# BUILDING CODE OF AUSTRALIA COMPLIANCE ASSESSMENT REPORT

Three storey commercial building with two storey basement carpark

21 Canterbury Road, Punchbowl

REPORT NO. ► PROJECT 9633 - Rev 2.0

D1.4  
Exit Travel Distances

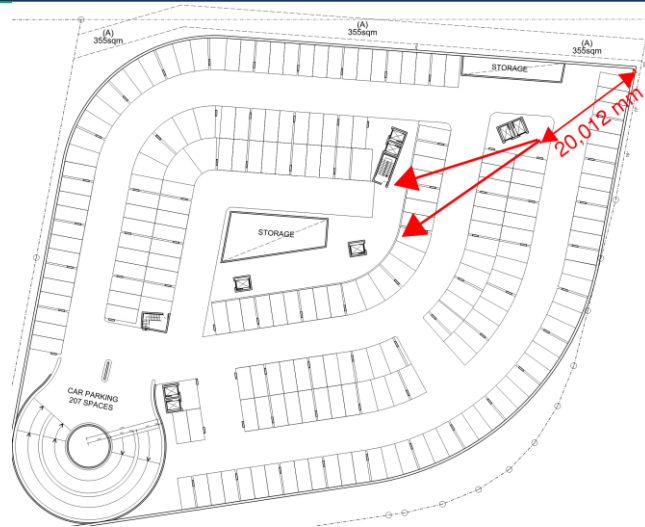
**Basement 2 - The exit travel distance is greater than 40m, maximum being 48.8m.**

**Basement 2 – The distance to a point of choice from the north eastern corner after 20m is not in “different directions”, and therefore does not comply. Refer to the marked up plan detailing the distance to a point of choice after 20m.**

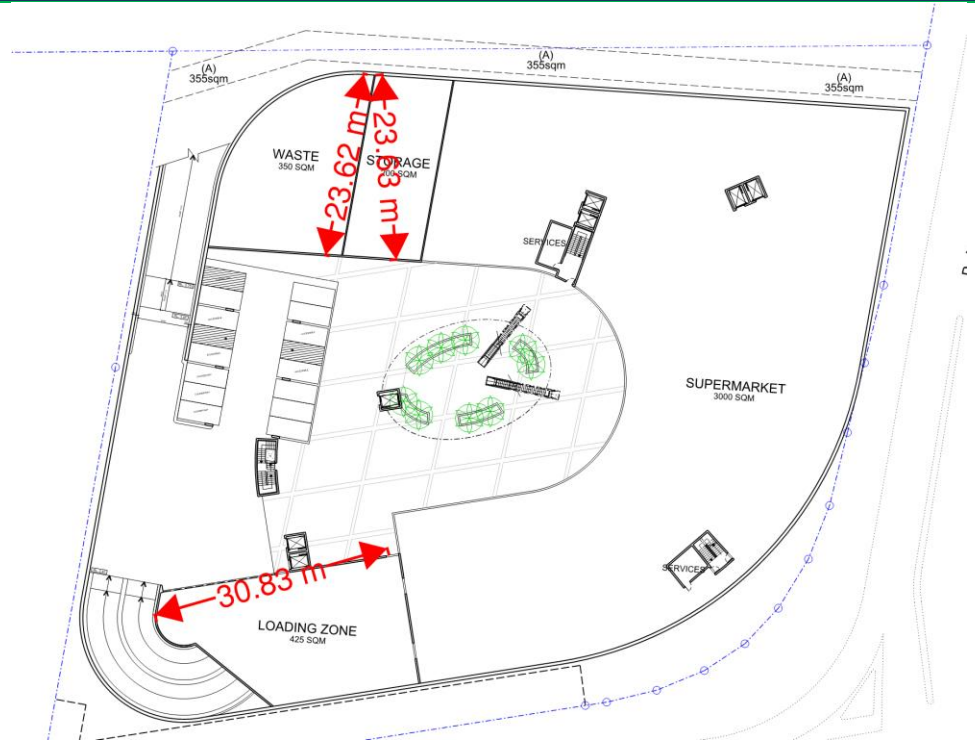
**Basement 1 - The exit travel distance is greater than 40m, maximum being 51.4m. The travel distance will be greatly increase upon fitout of the supermarket.**

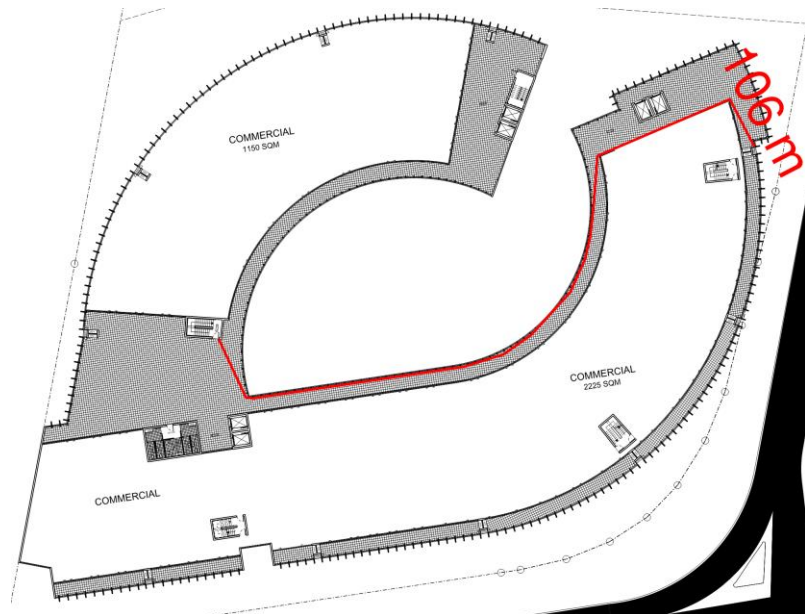
**Basement 1 – The distance to a point of choice from the “Waste”, Storage” and “Loading Zone” is greater than 20m, maximum being 30.83m. Refer to the marked-up plan detailing the distance to a point of choice after 20m.**

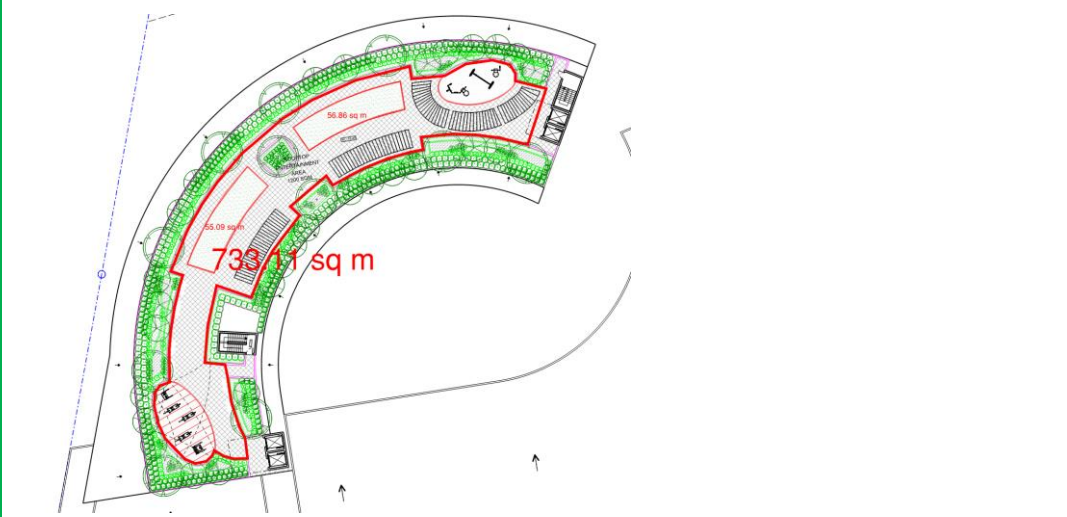
**Level 1 & 2 – The distance to a point of choice from the north eastern corner is greater than 20m, being 106m.**  
**Please note D1.2 requires access to exits must not pass through another SOU.**  
**An additional exit will be required.**

<p>D1.5 Distance Between Alternative Exits</p>	<p><b>Roof - Exits that are required as alternative means of egress is greater than 60m, being 72.58m.</b></p>
--	--

D1.6  
Dimensions of Exits and paths of Travel to Exits

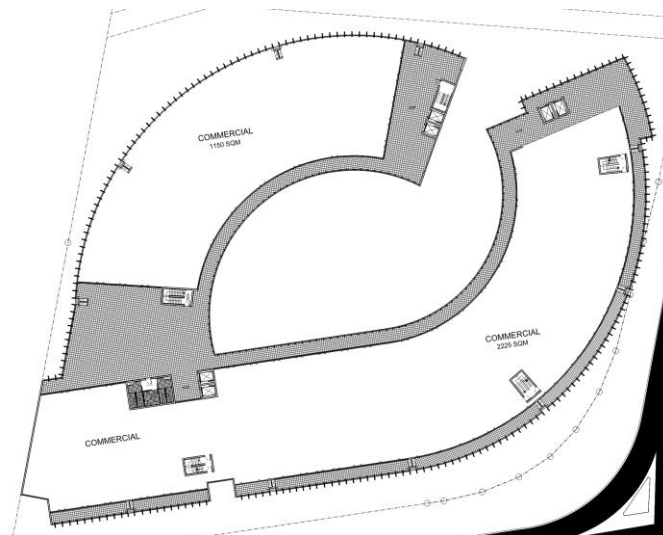
**Rooftop – The architect is required to nominate the proposed population of the “Rooftop Entertainment Area”.**  
**Under BCA Clause D1.13 a “public hall” (closest use in D1.13) details that 1m<sup>2</sup> per person. Therefore, the population of the “Rooftop Entertainment Area” would be 622 people.**

**Based on the population of 622 people the required aggregate width is 6m.**  
**The aggregate width of the proposed stairway is 2m.**

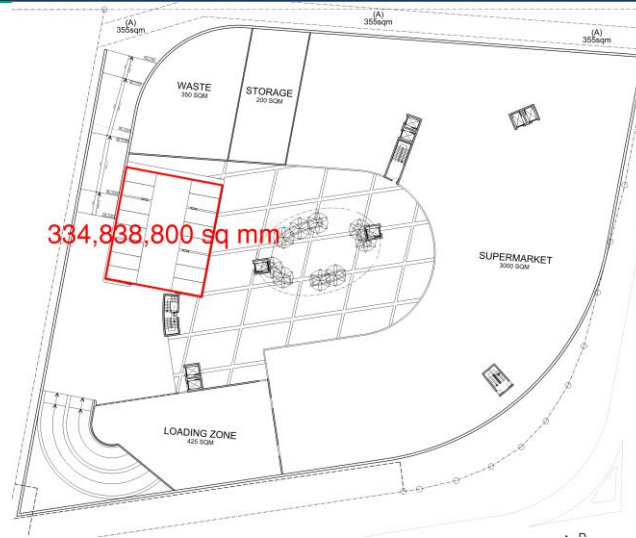
**Basement 1 - Under BCA Clause D1.13 a “shop” (closest use in D1.13) details that 5m<sup>2</sup> per person. Therefore, the population of the shop would be 600 people.**

**Based on the shop population of 600 people the required aggregate width is 5.5m.**

**The aggregate width of the stairways is 3m. Does not comply**

D1.7  
 Travel via Fire Isolated  
 Stairs

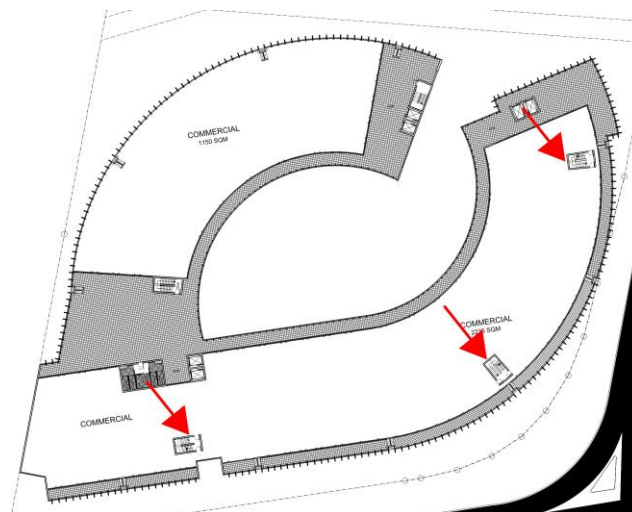
**The supermarket on Basement 1 does not occupy all of the storey and therefore the FIS is not permitted to open directly into it.**

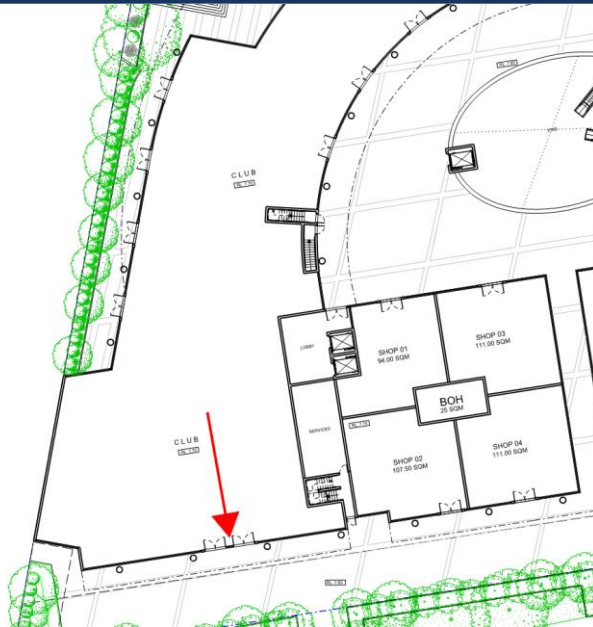
**Ground Floor – An airlock is required to be provided from the “Service Room” discharging into the fire-isolated stairway.**

**The commercial tenancy on Level 1 & 2 currently occupies the whole floor and therefore complies, however, where the floor is divided in the future it will create a non-compliance where the doorways open directly open into the fire isolated stairway. This should be considered at this stage.**

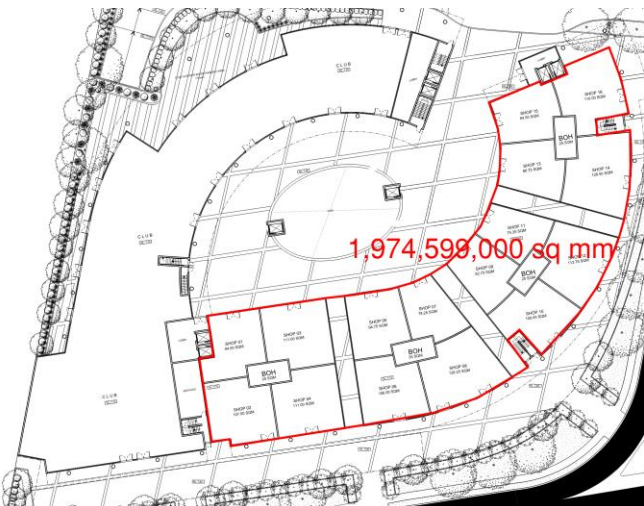
**Level 1 & 2 & Rooftop - The doorways discharging into the fire-isolated must swing in the direction of egress.**
